## STATEMENT OF ENVIRONMENTAL EFFECTS

### S4.55 (1A) Modification Application – SSD 9477 Catherine Field Primary School

PR148079  
SSD Modification  
1  
24 September 2020

## MODIFICATION REPORT FOR SSD 9477

Figure 1 SSD-9477 Extract of approved site plan showing car park (Source: Perumal Pedavoli, May 2020)

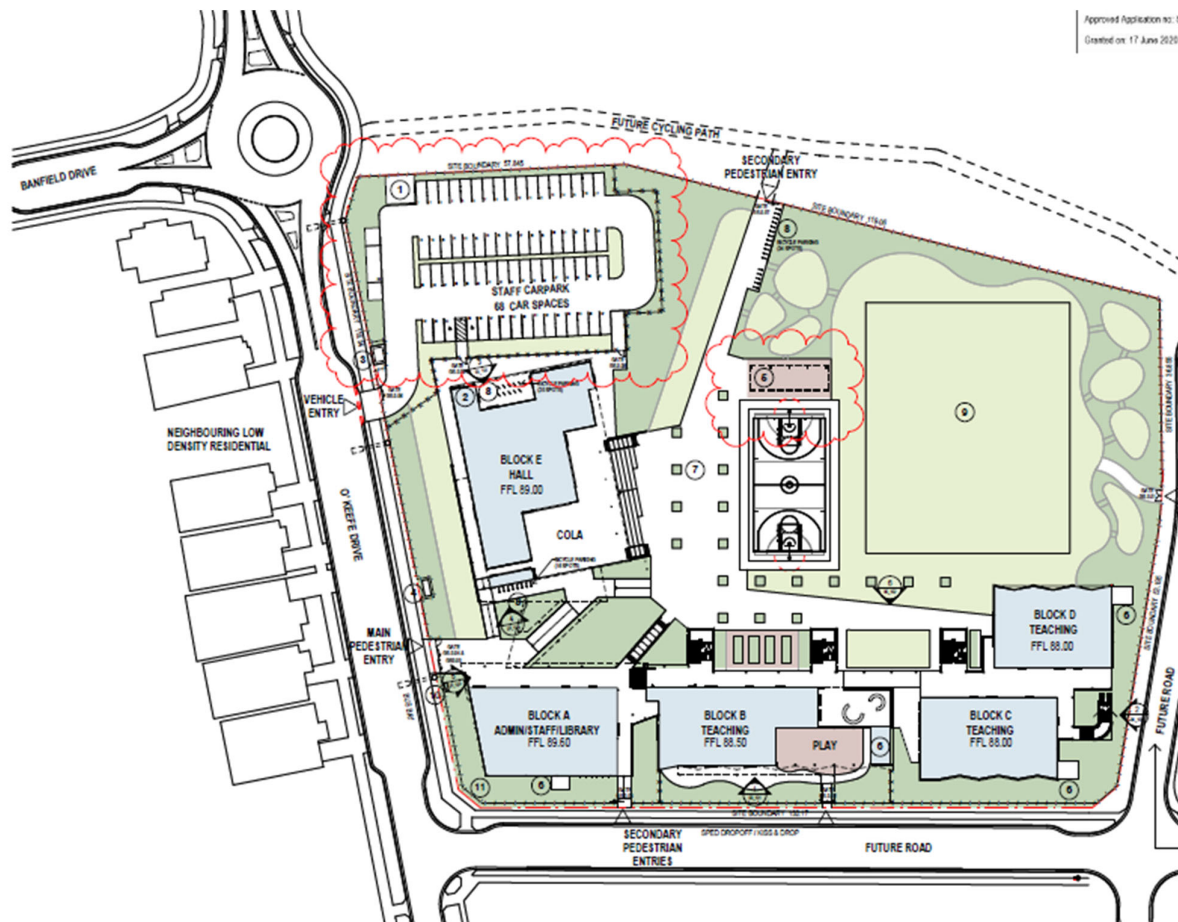
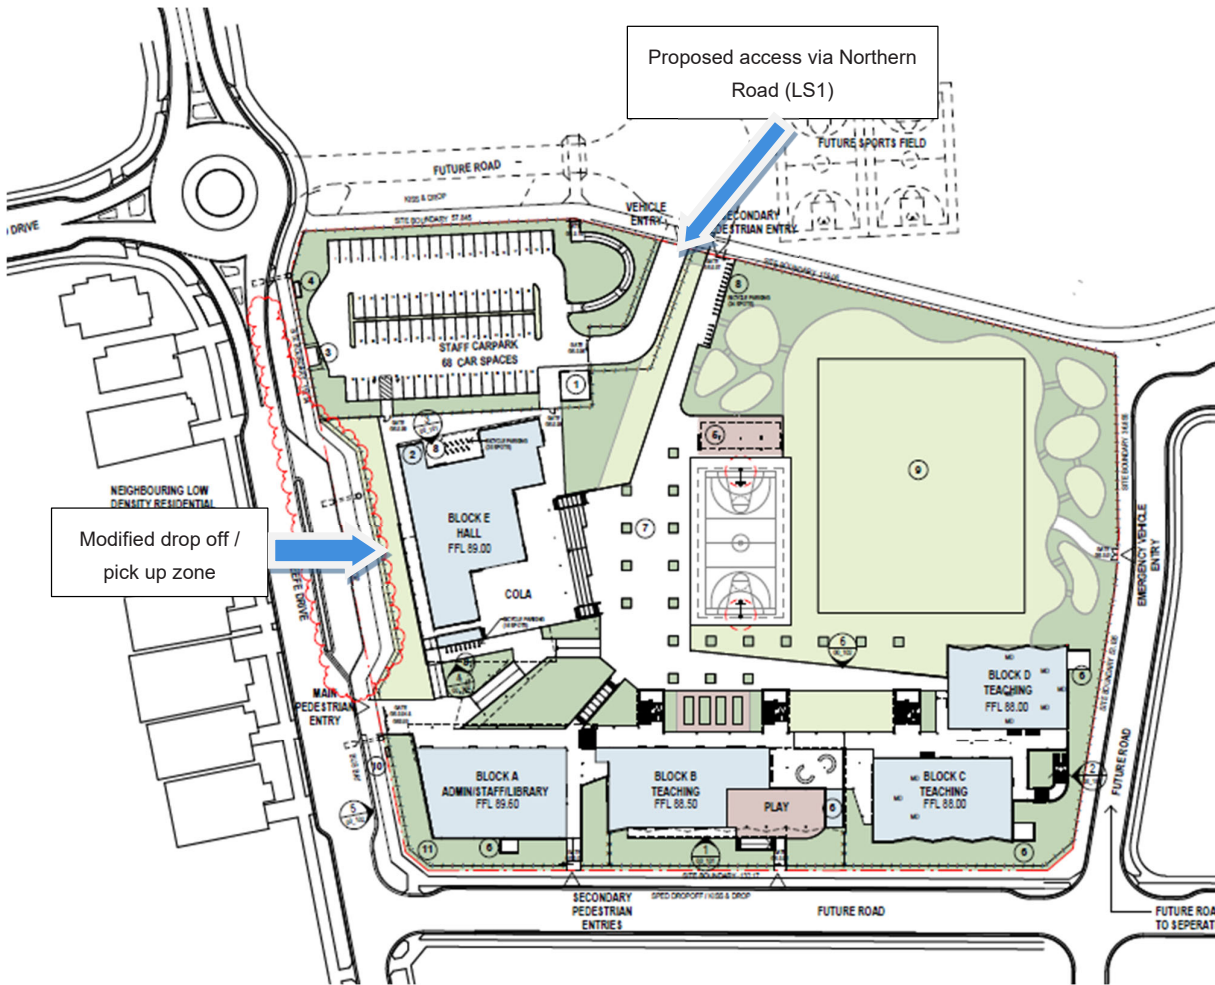
- Relocate the car park access from the western frontage to the Northern Road (LS1), refer to **Figure 1** and **Figure 2**. The car parking numbers remain as approved at 68 spaces and the waste pad has been relocated to the south-eastern corner which is an improved location that is out of view from the public domain. The proposed access to the staff carpark is via a new crossover connection to the cul-de-sac to the eastern end of the Northern Road (LS1) which is currently under assessment by Camden Council under DA-2020/568 (Lodged 14 August 2020). Access to / from the car park from Northern Road (LS1) has been tested with a swept path assessment using a 10.24m Waste Collection Vehicle as demonstrated in the Transport Statement prepared by Ason Group. The relocated access will provide better separation between staff vehicle movements and all other vehicle movements associated with the school. The relocated access arrangements will require some amendment to planned earthworks on site in this location. A revised bulk earthworks plan (NHQC2-CF-CV-S-DDC203.01 (Revision H) has been provided with the modification package.

- Construction of an amended drop-off / pick-up zone (DOPUZ) on the western frontage along O'Keefe Drive, **Figure 1** and **2**. It will include a widened, indented DOPUZ, where a median is retained to allow for the installation of pedestrian fencing which provide additional safety benefits for DOPUZ users. It will provided the opportunity to cater for wider kerbside bays, designed based on adoption of parallel kerbside parking bay dimensions based on AS2890.6:2009 of 3.2m wide by 7.8m long bays should the need arise for special education students and families. It will also provide the opportunity for the DOPUZ be used for school bus pick-up / set-down in the future, when road connection between the northern and southern section of O'Keefe Drive is completed in and around 2023.

**Figure 2** SSD-9477 Extract of proposed modified site plan showing car park and DOPUZ (Source: Perumal Pedavoli, 17/09/20)

Figure 3 Site Plan – Temporary Car Park Access (Source: Perumal Pedavoli, September 2020)

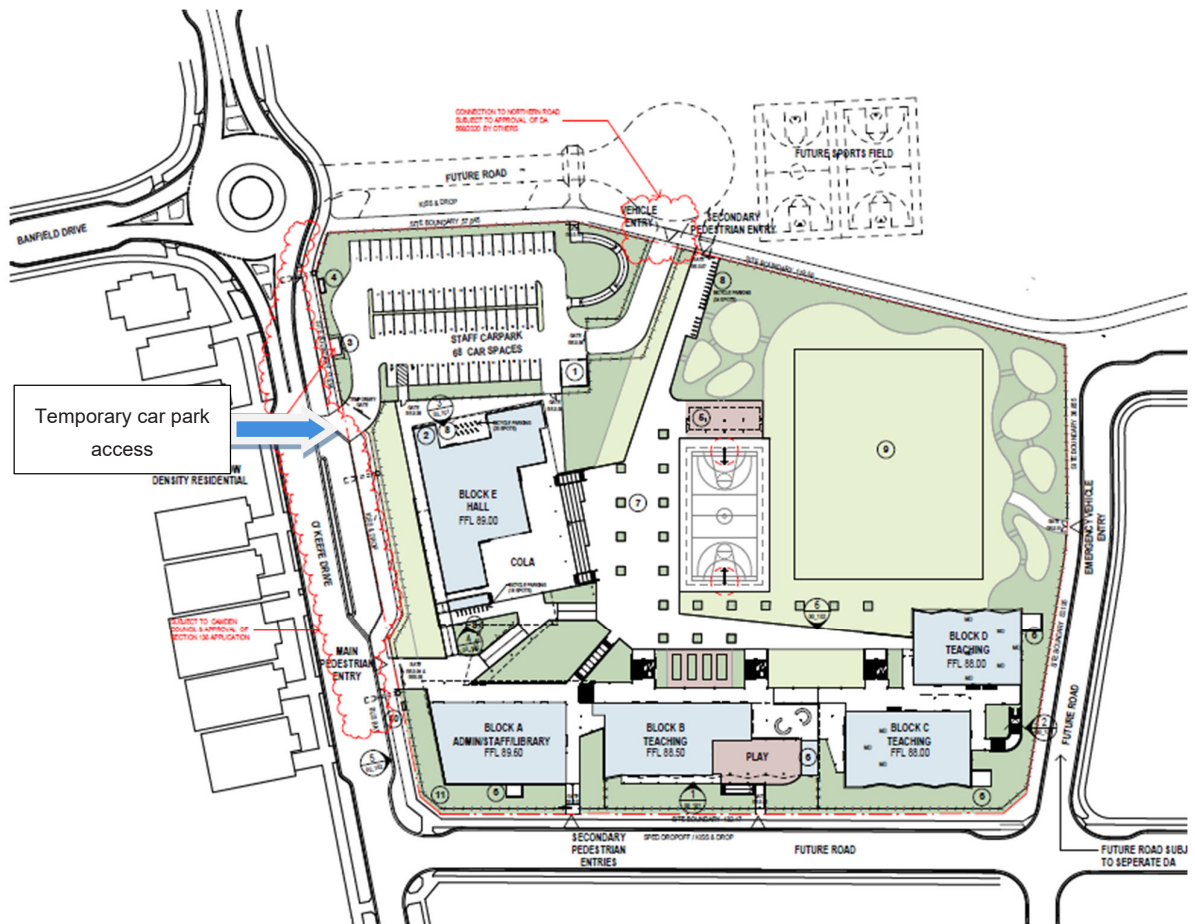
- Provide temporary access to the car park via O'Keefe Drive, refer to **Figure 3**. The proposed temporary access is for contingency purpose and will only be constructed should SI NSW and Hansen Yuncken be notified of a delay in the approvals associated with the Northern Road (LS1) or should associated works be delayed whereby necessary roadworks cannot be completed, and necessary documentation cannot be completed on-time to allow for access to / from the staff car park by Day 1, Term 1 of 2021. The proposed driveway access has been designed to accommodate a 10.24m Waste Collection Vehicle with a width of between ~9.1m which was informed by swept path analysis. Swept path analysis also demonstrates uninterrupted two-way for private vehicles. Should the Temporary Access connection be considered necessary, it is expected that notification to Council will be made in December 2020. The temporary access arrangements will require some amendment to planned earthworks on site in this location. A revised bulk earthworks plan (NHQC2-CF-CV-S-SK211.01 (Revision 1) has been provided with the modification package.
